City of Sugar Hill
Planning Staff Report
VAR-20-005

DATE: August 31, 2020
TO: Mayor and City Council
FROM: Planning Director
SUBJECT: Variance Request VAR-20-005
Lidl US – Northwest corner Nelson Brogdon Boulevard and Sycamore Road

SHEET TITLE:
VARIANCE SITE PLAN

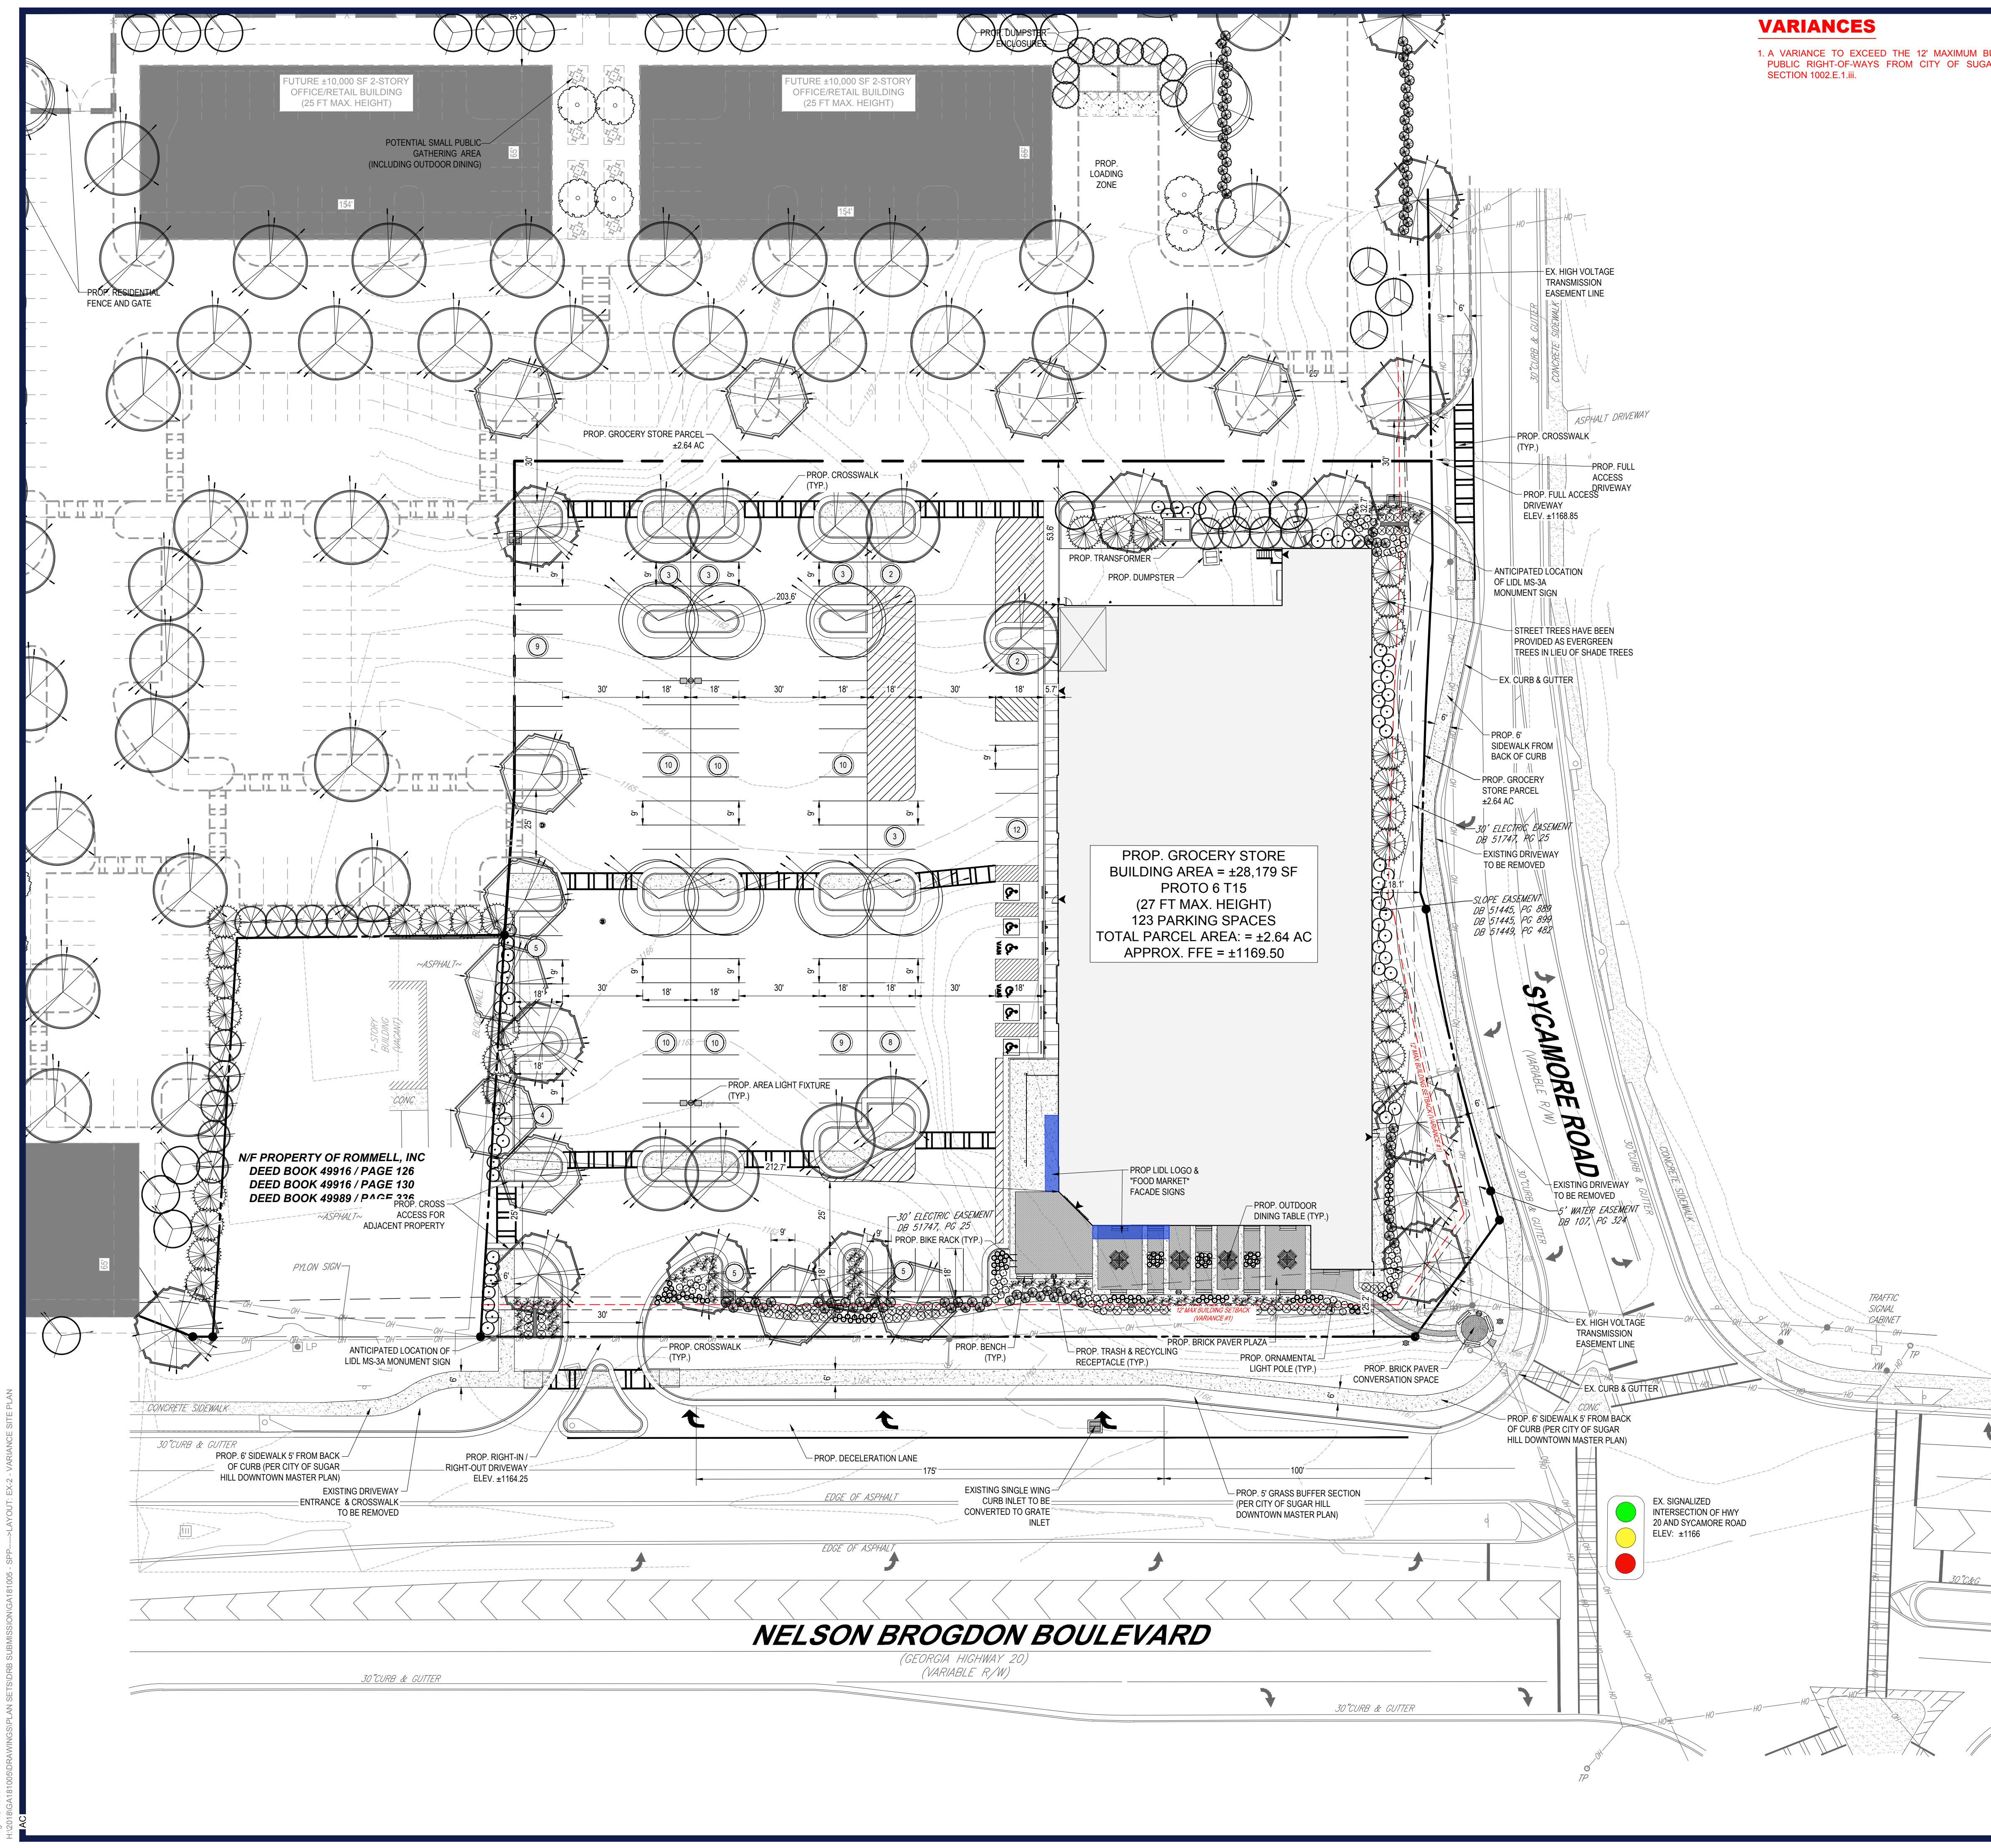
Variance #1 (1002.E.1.iii): Increase maximum setback from 12 feet to +/- 25.2 feet along Highway 20 to accommodate an existing high voltage transmission easement running along Highway 20 and additional landscaping along Sycamore Road.

- **VARIANCE 1:** City of Sugar Hill Zoning Ordinance Section 1002.E.1.iii
The applicant is requesting a variance from Section 1002.E.1.iii to permit the proposed building outside of the 12' maximum building setback along both the Hwy 20 and Sycamore Road frontages.

The applicant is requesting a variance to increase the maximum building setback from 12 feet to +/-18.1 feet along Sycamore Road and from 12 feet to +/-25.2 feet along Hwy 20. There is an existing high voltage transmission easement running along both frontages which governs the placement of the building. For the Hwy 20 frontage, the building line has been placed right on this easement. For the Sycamore Road frontage, the easement effectively reduces the available street tree planting area to meet the minimum density requirement, and therefore, the building has been placed to allow for enough space to meet this requirement. Since this an existing easement, the special

Approval with conditions for variances #1 and #2. Denial of variances #3, #4 and #5.

Right Elevation (facing Nelson Brogdon Blvd)

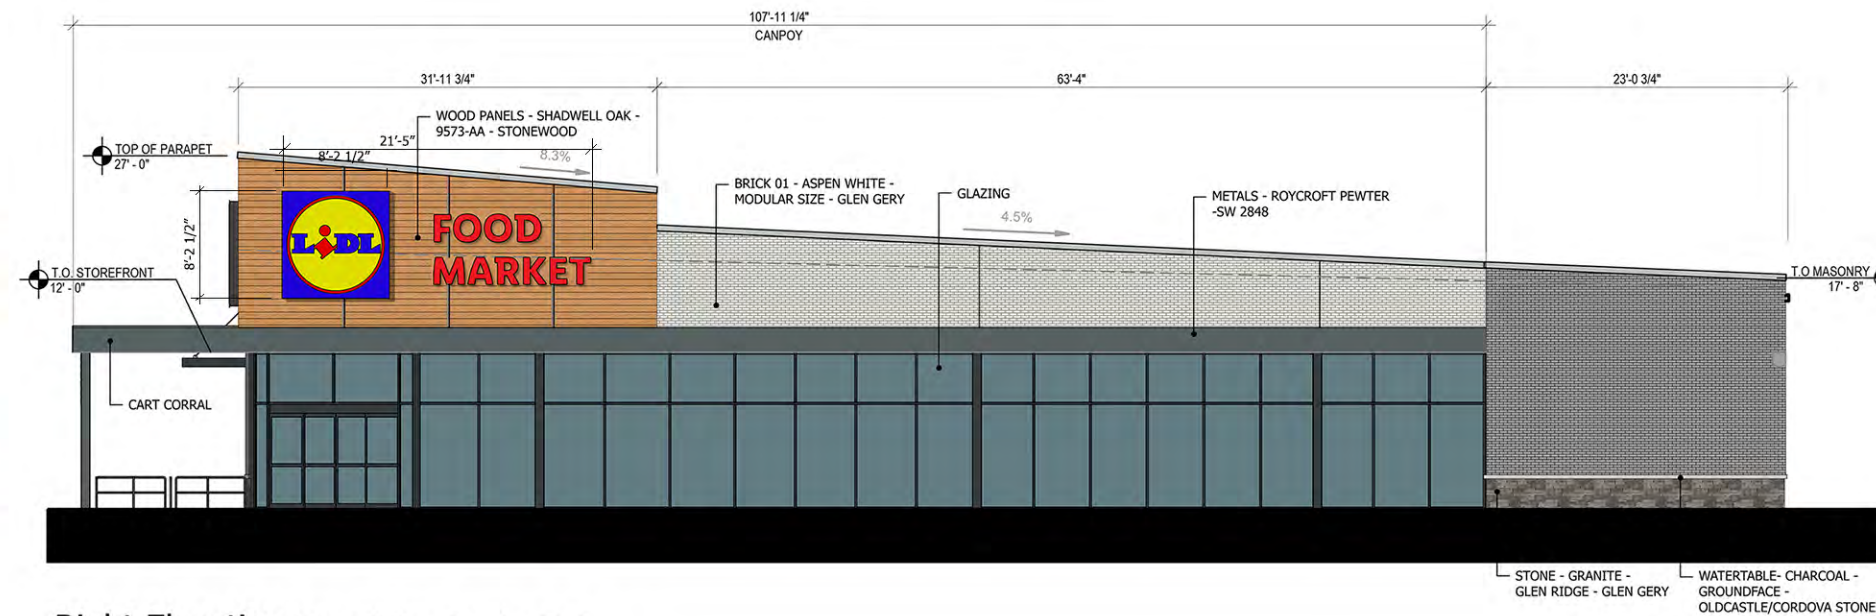
Variance #3 (1002.E.2.iv): Reduce 50% minimum transparency requirement for street-facing building facades.

The applicant is requesting that less than 50% transparency for the street facing façades be considered for this location. Due to the nature of the internal plan, the right façade, facing Highway 20, is just shy of the 50% and would require transparent windows in a restroom. This would cause a security and privacy concern. The back façade, facing Sycamore Road, has an internal layout of shelving and refrigerated cases along this façade. We have proposed some ribbon windows above the shelving and cases, as a concerted effort towards the transparency requirement and to help break up the façade, while also providing additional daylight into the sales floor. Another item of consideration is that this façade is heavily landscaped to achieve the density requirement and the façade will not be very visible from the street.

Rear Elevation (facing Sycamore Road)

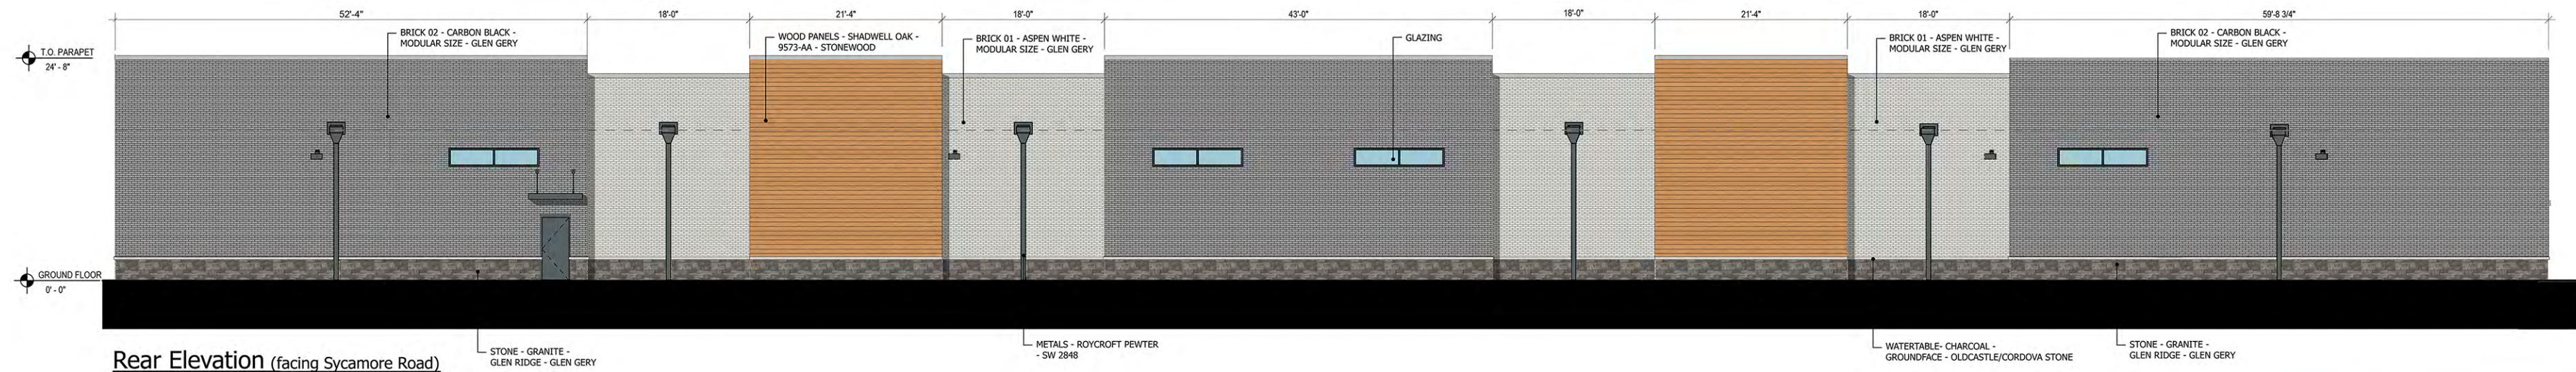
4. Landscaping along Sycamore Road shall be arranged to screen the building panels in no less than 20' increments. Landscape strip shall consist of at least two staggered rows of evergreen and semi-evergreen trees and shrubs native or adapted to the area. Trees shall be 6' tall at time of planting. Plantings shall be arranged to provide an effective visual screen of at least 20' in height at maturity. Landscape strip must not contain more than 1/3 of a single species and must be shown on a landscape plan to be approved by the city manager prior to receiving any permits.

Variance #2 (1002.E.2.i): Increase maximum building façade segment to 81 feet 5 inches from 20 feet.

The proposed Lidl store façade design has visually divided segments of articulation that are longer than the requested 20' increments for a wall longer than 40' in length. The applicant is requesting the consideration of allowing longer than 20' segments be accepted. A grocery store design has a larger scale one-story footprint than a typical commercial building. Therefore, the proposed visually divided segments are in proportion to the façade lengths and heights. In addition, different materials are introduced within proportionate segments, along with awnings, storefront and windows, varied parapet heights, and landscaping that help achieve an aesthetically pleasing façade.
